## Notice of Decision & SEPA DNS

### FVRL Woodland Library

### Site Plan Review & SEPA DNS

Land Use Application Nos.:	SPR-22-013 (Site Plan Review Type II) SEP-22-012 (SEPA)
Applicant:	Hacker Architects C/O Amelie Reynaud 555 SE MLK Blvd, Suite 501 Portland, OR 97214
Property Owner:	Fort Vancouver Regional Libraries C/O Amelia Shelley 2018 Grand Blvd Vancouver, WA 98661
Site Location:	828 Goerig Street Woodland, WA 98674
Parcel No. & Size:	50480 (1.9 Acres)
Zoning Designation:	C-2, Highway Commercial
Date Application Received:	December 9 <sup>th</sup> , 2022
Notice of Complete Application Issued:	December 21 <sup>st</sup> , 2022
Notice of Application & Likely DNS issued:	December 22 <sup>nd</sup> , 2022
Comment Period & SEPA Appeal Period Ended:	January 11 <sup>th</sup> , 2023
Notice of Decision Issued:	January 27 <sup>th</sup> , 2023
DRC Decision	Approve with Conditions

Landscaping Plan

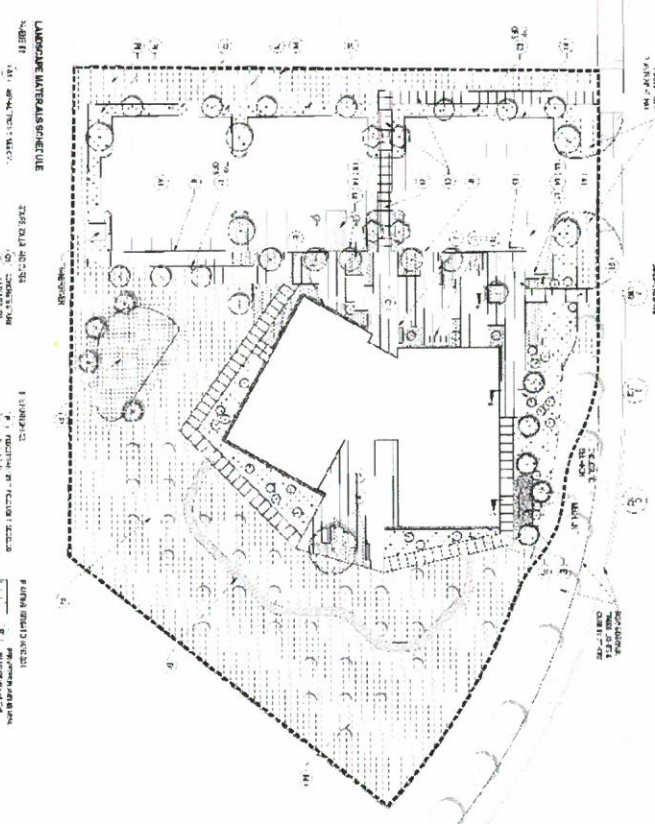
**Finding 17:** Landscaping is proposed between the building and Lakeshore Drive with a mix of trees, shrubs and ground cover, and a pedestrian access path and entry court will be located at a level with the building. This meets the requirements outlined within WMC 17.36.070(3) *See Attachment A – Site Plan and Attachment B – Landscaping Plan*

**Finding 23:** The landscaping strip between the fronting streets and parking lot exceeds 10 ft in width and contains a combination of shrubs and trees. *See Attachment B – Landscaping Plan.*

**Finding 35:** There is a 20+ ft landscaping strip shown on the landscaping plan that includes a variety of shrubs, trees, and ground cover. This meets this standard. *See Attachment B – Landscaping Plan.*
